## Preliminary Development Review Report

<b>Tracking Number:</b>	PDR 1001312
<b>Applicant:</b>	CLARK GASSEN 13911 RIDGEDALE DRIVE #125 MINNETONKA, MN 55305
<b>Site Address:</b>	4264 UPTON AVE S
<b>Date Submitted:</b>	20-MAY-2015
<b>Date Reviewed:</b>	03- JUN-2015

Proposed mixed use development with underground and at grade parking.

**Failure 1: TWO OF THE FRAMES do not meet criteria and do not: "include the area affected by cast shadows".**

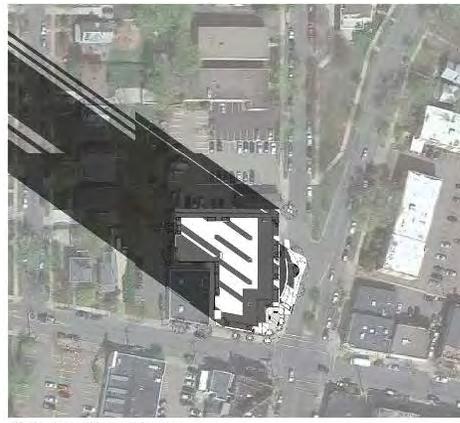
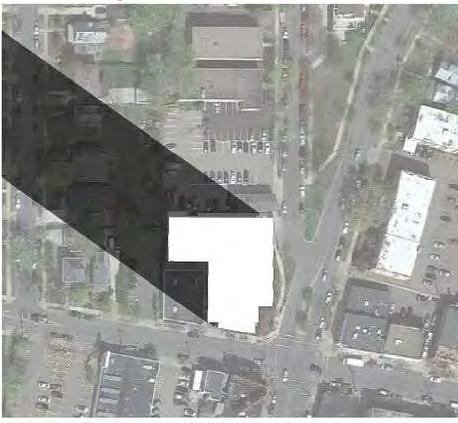
- 1) The study should include the area affected by cast shadows of the proposed building

- 3) On the above noted days it should show the shadowing at an hour after sunrise, noon, and an hour before sunset.
